Ananta Garments Ltd (Extension)

05 May 2026

1. Building Information

Floor build-up

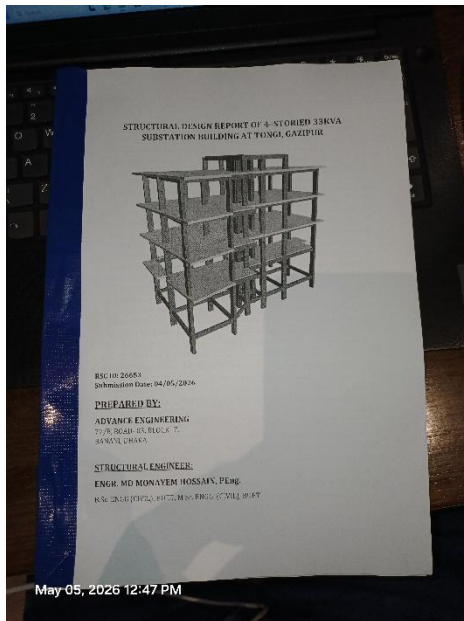
Observation-2: Lack of information in the prepared drawings. (Utility Building)

Description: Floor build-up details in the washing area and canopy details of the ground floor were not provided in the as-built drawings.

Building engineer is required to survey the structure and update the as-built drawing.

2.2 Tensile Strength of Rebar

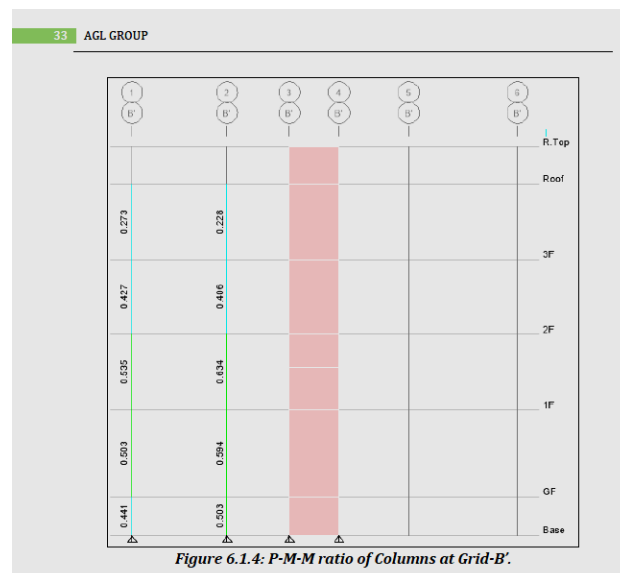
Description: In the design report, the yield strength of rebar is considered 500 MPa (72,500 psi). But no material test report was available to confirm the design strength. Also, the adequacy of the RC shear wall was not incorporated in the provided design report. The building engineer is required to incorporate all types of adequacy checks into the design report and submit them to the RSC for review.
